# DSA CODE AMENDMENT DEVELOPMENT

Tracking		Applicable Code
Date Received:	-	Applicable Code Section(s): Chapter 1, Section 1.9.1.3 Scope and Administration
DSA Tracking Number:	ITEM 1.01	
Date Reviewed:	11/25/19	
Status:	CAC Review	Topic: Public housing

**Figure 11B-604.3.2 (Exception)**  
**OVERLAP OF WATER CLOSET CLEARENCE IN RESIDENTIAL DWELLING UNITS**

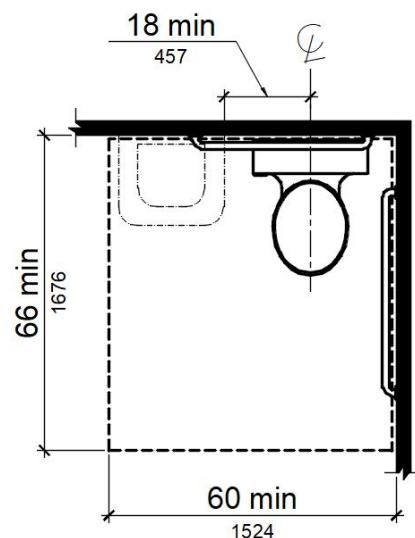
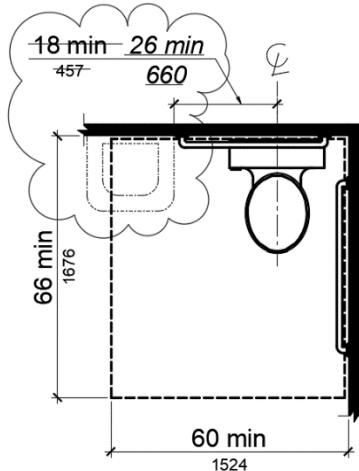
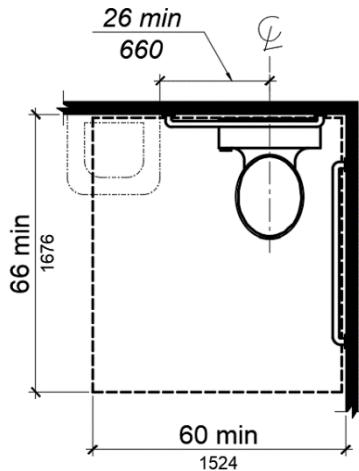
**Exception:** In residential dwelling units, a lavatory complying with Section 11B-606 shall be permitted on the rear wall ~~18 inches (457 mm)~~ 26 inches (660 mm) minimum from the water closet centerline where the clearance at the water closet is 66 inches (1676 mm) minimum measured perpendicular from the rear wall.

**Exception:** In residential dwelling units, a lavatory complying with Section 11B-606 shall be permitted on the rear wall 26 inches (660 mm) minimum from the water closet centerline where the clearance at the water closet is 66 inches (1676 mm) minimum measured perpendicular from the rear wall.

**FIGURE 11B-604.8.1.1.2  
MANEUVERING SPACE WITH SIDE-OPENING DOOR**

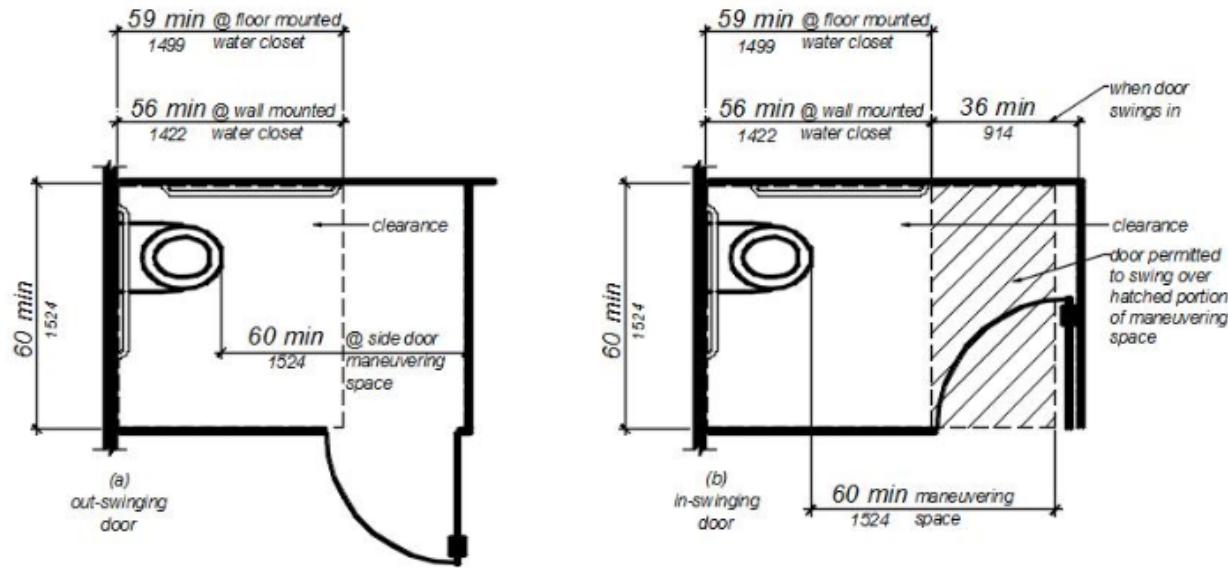
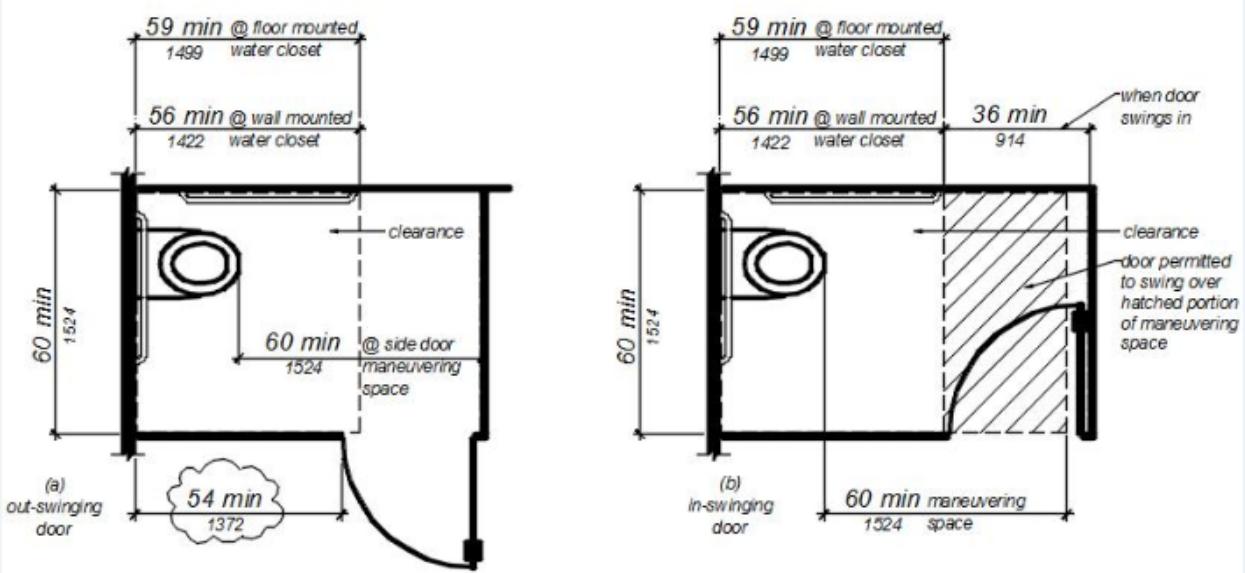
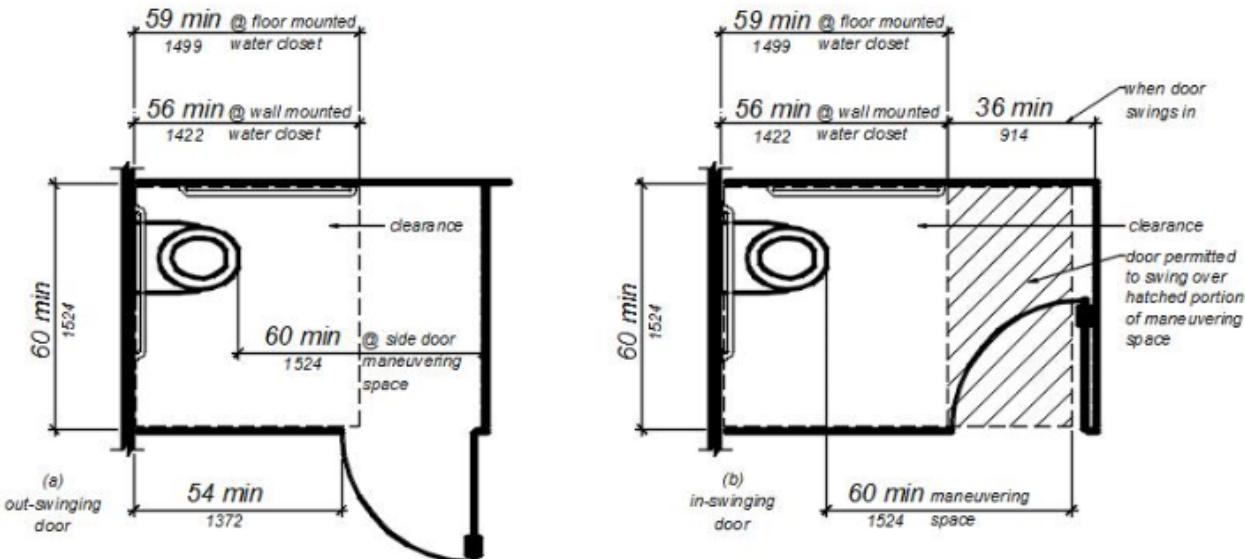
The Division of the State Architect is proposing to amend Section 11B-604.8.1.2 and Figure 11B-604.8.1.2 to revise the required location for out-swinging toilet compartment doors in the side wall or partition of an accessible toilet compartment. The current provisions require the door to be 4 inches maximum from the front partition. This proposal allows the toilet compartment door to be located in a variety of locations in the side wall or partition while maintaining equal or greater accessibility than the current California Building Code Chapter 11B requirements and the 2010 ADA Standards for Accessible Design.

**11B-604.8.1.2 Doors.** Toilet compartment doors... Doors shall be located in the front partition or in the side wall or partition farthest from the water closet. Where located in the front partition, the door opening shall be 4 inches (102 mm) maximum from the side wall or partition farthest from the water closet. Where located in the side wall or partition, *the door opening shall be farthest from the water closet and shall be 54 inches (1372 mm) minimum from the rear wall.* ...

**Figure 11B-608.5.2**  
**STANDARD ROLL-IN TYPE SHOWER COMPARTMENT CONTROL LOCATION**

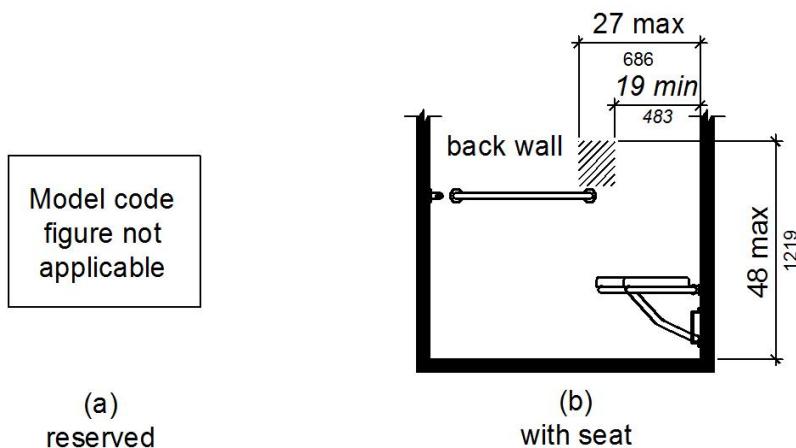
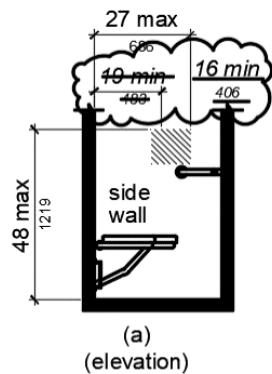
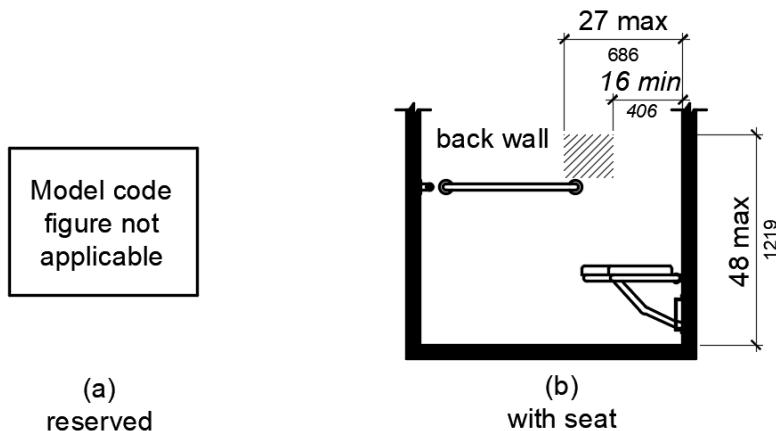
**11B-608.5.2 Standard roll-in type shower compartments.** In standard roll-in type shower compartments, operable parts of controls and faucets shall be installed on the controls, faucets, and the shower spray unit shall be located on the back wall of the compartment adjacent to the seat wall 19 inches (483 mm) minimum and 16 inches (406 mm) minimum and 27 inches (686 mm) maximum from the seat wall; and shall be located above the grab bar, but no higher than 48 inches (1219 mm) above the shower floor, with their centerline at 39 inches (991 mm) to 41 inches (1041 mm) above the shower floor.

**11B-608.5.2 Standard roll-in type shower compartments.** In standard roll-in type shower compartments, the controls, faucets, and the shower spray unit shall be located on *the back wall of the compartment adjacent to the seat wall* 16 inches (406 mm) minimum and 27 inches (686 mm) maximum from the seat wall; and shall be located above the grab bar, but no higher than 48 inches (1219 mm) above the shower floor.

**Figure 11B-608.5.3  
ALTERNATE ROLL-IN TYPE SHOWER COMPARTMENT CONTROL LOCATION**

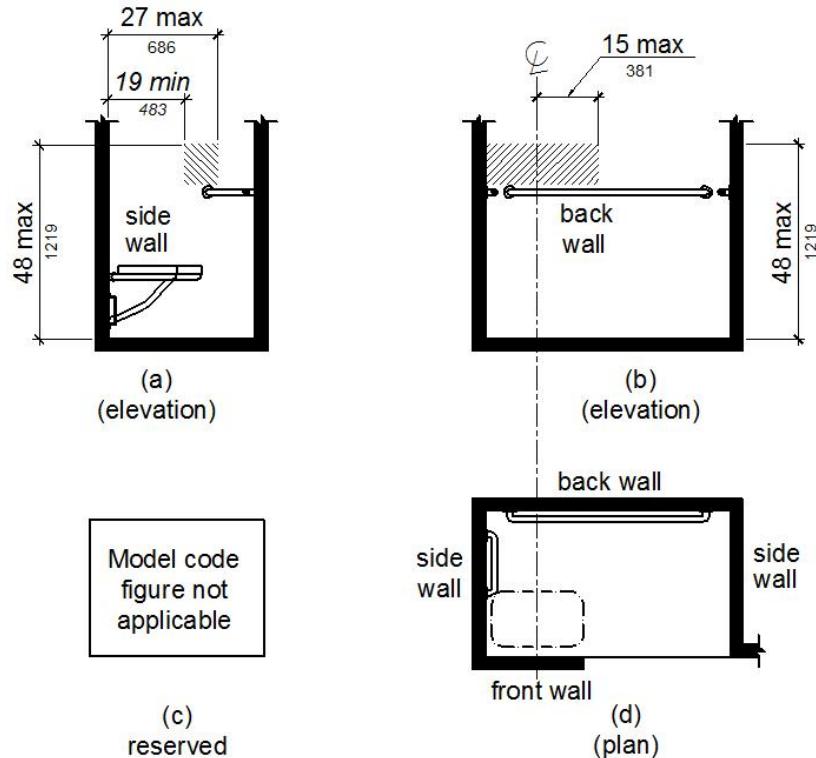
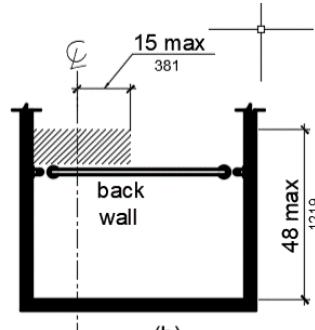
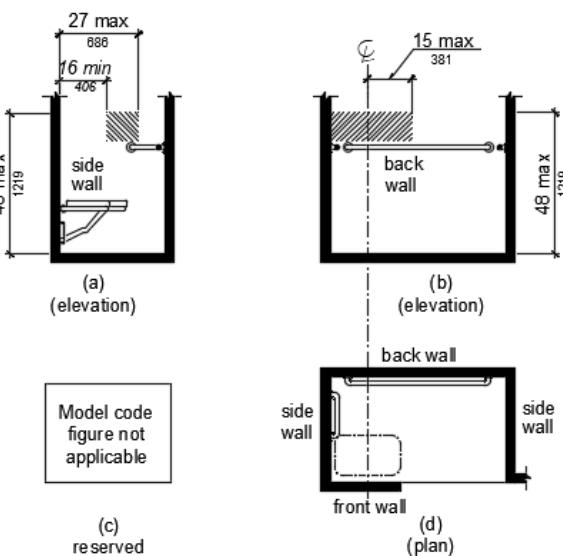
**11B-608.5.3 Alternate roll-in type shower compartments.** In alternate roll-in type shower compartments, operable parts of controls and faucets shall be installed the controls, faucets, and shower spray unit shall be located on the side wall of the compartment adjacent to the seat wall 19 inches (483 mm) minimum and 16 inches (406 mm) minimum and 27 inches (686 mm) maximum from the seat wall; or shall be located on the back wall opposite the seat 15 inches (381 mm) maximum, left or right of the centerline of the seat. and The operable parts of controls, faucets, and shower spray units shall be located above the grab bar, but no higher than 48 inches (1219 mm) above the shower floor, with their centerline at 39 inches (991 mm) to 41 inches (1041 mm) above the shower floor. Operable parts of the shower spray unit, including the handle, shall be installed on the side wall of the compartment adjacent to the seat wall 17 inches (432 mm) minimum and 19 inches (483 mm) maximum from the seat wall or on the back wall opposite the seat 15 inches (381 mm) maximum, left or right, of the centerline of the seat; and shall be located above the grab bar, but no higher than 48 inches (1219 mm) above the shower floor.

**11B-608.5.3 Alternate roll-in type shower compartments.** In alternate roll-in type shower compartments, the controls, faucets, and shower spray unit shall be located *on the side wall of the compartment adjacent to the seat* 16 inches (406 mm) minimum and 27 inches (686 mm) maximum from the seat wall or shall be located on the back wall opposite the seat 15 inches (381 mm) maximum, left or right of the centerline of the seat. The controls, faucets, and shower spray units shall be located above the grab bar, but no higher than 48 inches (1219 mm) above the shower floor.
